# Access Compliance Report

## Public Rights-of-Way

### (Curb Ramps)

Intersection ID: 9356	Main Street: E_36TH_ST	Cross Street: N_TRYON_ST	Location: NW
ADA ID: 60B9ED23D950	Ramp Type: Perp	Initial Pass/Fail: Fail	Overall Compliance: No
			Severity Score: 46.25

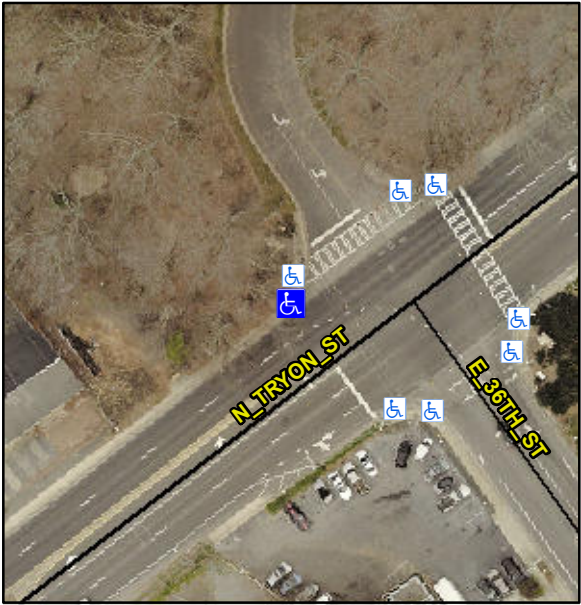
Codes/Mitigation Info/Possible Solution			Field Measurements/Component Compliance			
	Possible Solutions:		<b>Compliance</b>	<b>Description</b>	<b>Data</b>	<b>Compliance</b>
	<b>Remove &amp; Replace Entire Ramp.</b>		<b>No</b>	Ramp Length (in)	<b>60.0</b>	<b>No</b>
			<b>No</b>	Ramp Width (in)	<b>36.0</b>	<b>No</b>
			<b>N/A</b>	Flare Type LT	<b>N/A</b>	<b>N/A</b>
			<b>N/A</b>	Flare Slope LT (%)	<b>N/A</b>	<b>N/A</b>
			<b>N/A</b>	Flare Traversable LT?	<b>N/A</b>	<b>N/A</b>
			<b>N/A</b>	Landing Length (in)	<b>N/A</b>	<b>N/A</b>
			<b>N/A</b>	Landing Width (in)	<b>N/A</b>	<b>N/A</b>
			<b>N/A</b>	Landing Slope (%)	<b>N/A</b>	<b>N/A</b>
			<b>N/A</b>	Landing X Slope (%)	<b>N/A</b>	<b>N/A</b>
<p>Surveyor Notes:</p> <p><b>N/A</b></p> <p>PROW/ADA:</p> <p><b>Not Found, R304.5.1, R304.2.2, R304.5.3</b></p>			<b>N/A</b>	Flare Type RT	<b>N/A</b>	<b>N/A</b>
			<b>N/A</b>	Flare Slope RT (%)	<b>N/A</b>	<b>N/A</b>

<b>N/A</b>	Flare Traversable RT?	<b>N/A</b>	<b>N/A</b>
			<b>N/A</b>	DWS Provided?	<b>N/A</b>	<b>N/A</b>
			<b>N/A</b>	DWS Contrast?	<b>N/A</b>	<b>N/A</b>
			<b>N/A</b>	DWS Length (in)	<b>N/A</b>	<b>N/A</b>
			<b>N/A</b>	DWS Full Width?	<b>N/A</b>	<b>N/A</b>
			<b>N/A</b>	DWS Offset (in)	<b>N/A</b>	<b>N/A</b>
			<b>N/A</b>	Gutter Slope (%)	<b>N/A</b>	<b>N/A</b>
			<b>N/A</b>	Gutter X Slope (%)	<b>N/A</b>	<b>N/A</b>
			<b>No</b>	Painted X Walk1?	<b>No</b>	<b>N/A</b>
				X Walk 1 Direction	<b>To SE</b>	<b>N/A</b>
			<b>N/A</b>	X Walk 1 Width (in)	<b>N/A</b>	<b>N/A</b>
				X Walk 1 Slope (%)	<b>2.8</b>	<b>N/A</b>
				X Walk 1 X Slope (%)	<b>5.6</b>	<b>N/A</b>
			<b>N/A</b>	Ramp inside XWalk1?	<b>N/A</b>	<b>N/A</b>
			<b>N/A</b>	Road Slope (%)	<b>N/A</b>	<b>N/A</b>
			<b>N/A</b>	Road X Slope (%)	<b>N/A</b>	<b>N/A</b>
			<b>N/A</b>	Any Obstructions?	<b>N/A</b>	<b>N/A</b>
				Obstruction Type		<b>N/A</b>
Total Cost:			<b>\$</b>	<b>1850.00</b>		<b>N/A</b>
